Subject: 24 School Street – Mounding Calculations/Stormwater Review

The emailed documents are to address the review comments by Nover-Armstrong Associates, Inc. (NAA) dated March 9, 2018. The package includes documents and plan as listed in the following:

We received and reviewed the review comments on groundwater mounding calculations/stormwater by Nover-Armstrong Associates, Inc. (NAA) dated March 9, 2018. The groundwater mounding analysis has been updated to incorporate the recommendations in the review comment letter. This letter briefly addresses the comments in the same sequence as in the comment letter by NAA. To facilitate the next round review, we quoted the comments first in *italic* and then followed by our response in **Bold**.

PROPOSED GRADING PLAN #24 SCHOOL STREET IN WAYLAND, MASS (MIDDLESEX COUNTY)

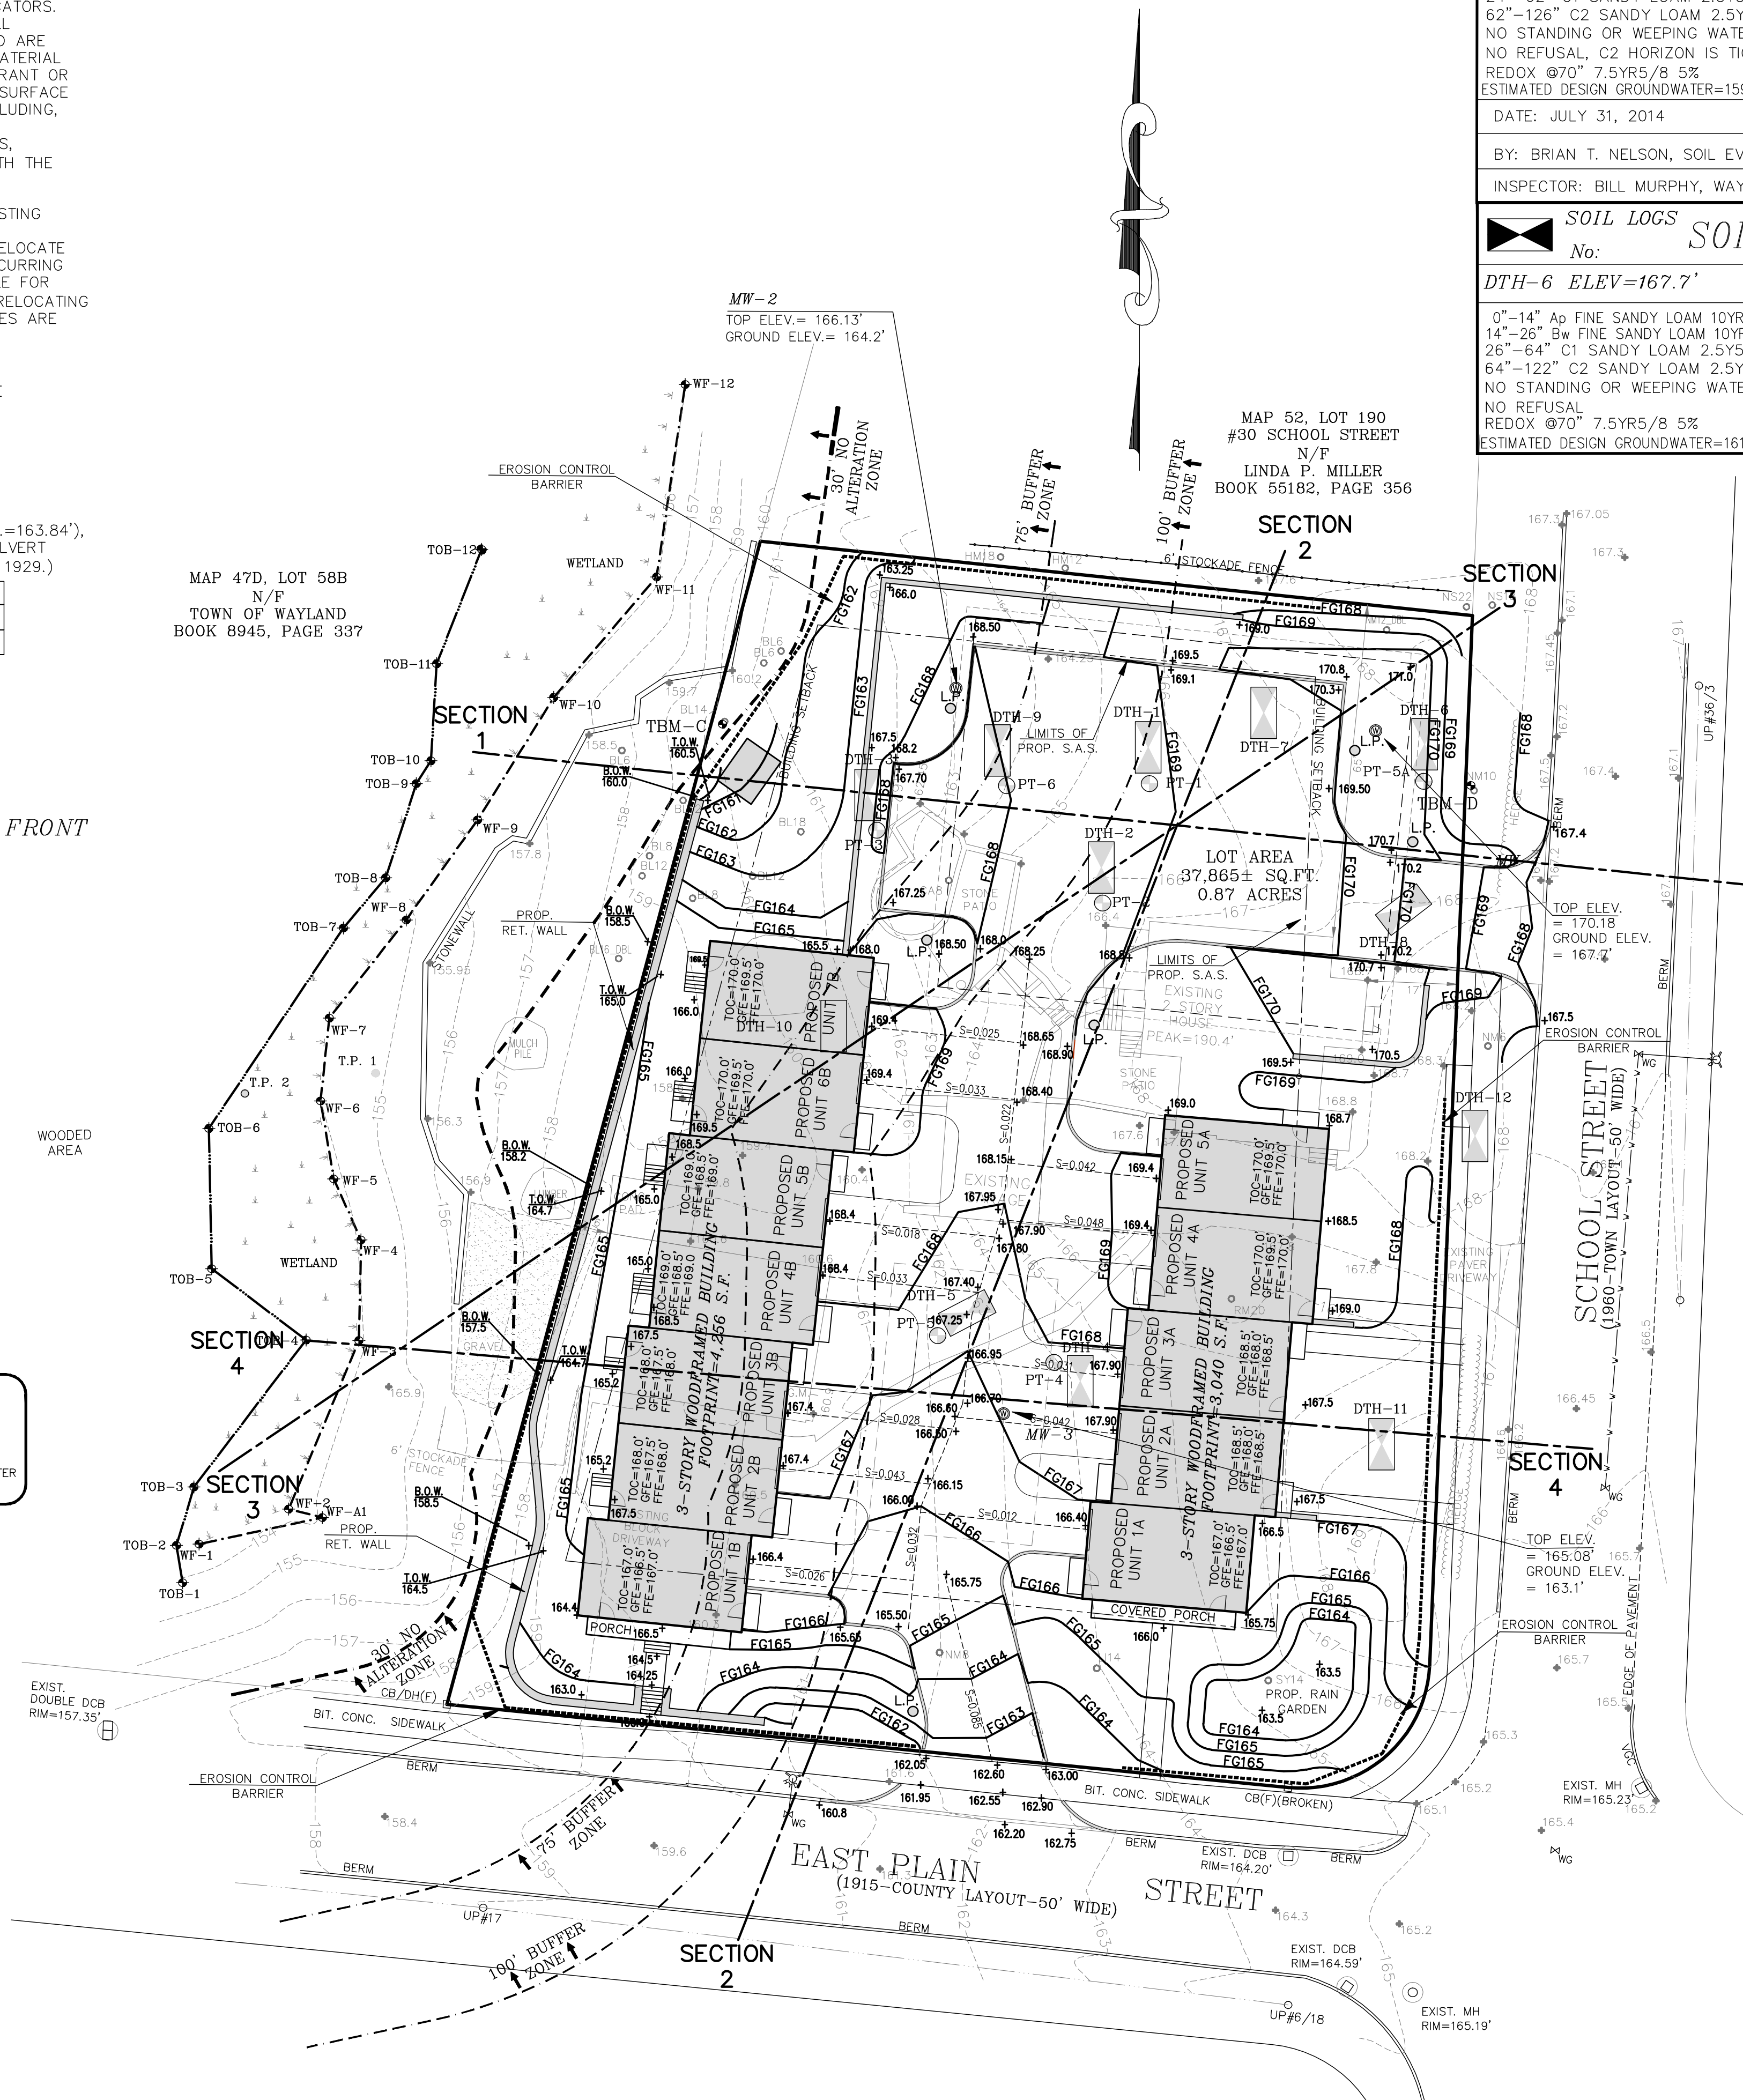
In addition, as requested at our working phone conference, four profiles across septic SAS and the stormwater infiltration area are plotted to show that the groundwater movement and mounding will not be impacted by the retain wall or building foundation as there will be no basement for all the buildings, which will built on quite amount of fill above groundwater. See the profiles for details. As the retaining wall footing in some locations may get close the high water table, it should be checked in the field to make sure the retaining wall footing will be set at or slightly above the seasonal high groundwater table to assure the proper groundwater movement. To add a safety factor here, a 6” thick crushed stones is recommended as the subbase of the retaining wall to facilitate the water move, which would be equivalent to more than 3 ft sandy soil flow passing capacity.
